TE Connectivity

Product Change Notification: E-18-012095

OJ/OJE/OJT/T77 packaging tray optimizing

tray comparison

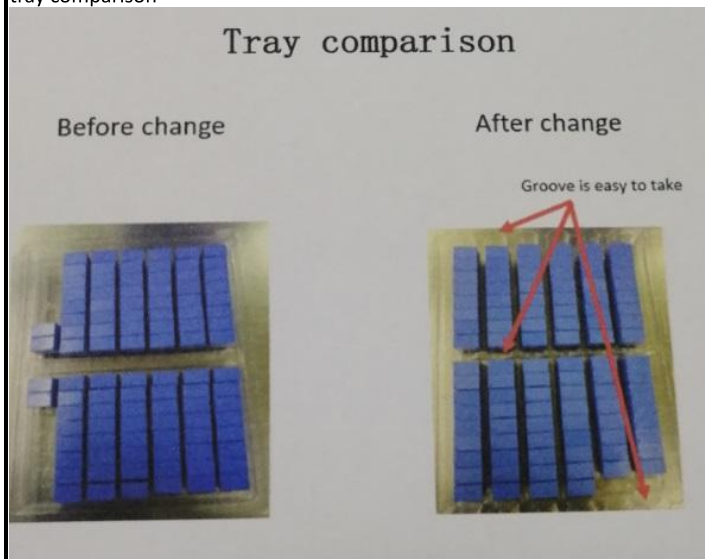
Change to the new simple packaging tray, that customer can easily take the relay from the tray.

Customer Request. Packaging optimizing, change to the new simple packaging tray, that customer can easily take the relay from the tray, as the attachment shows, will keep the same packaging carton, and no impact to relay function
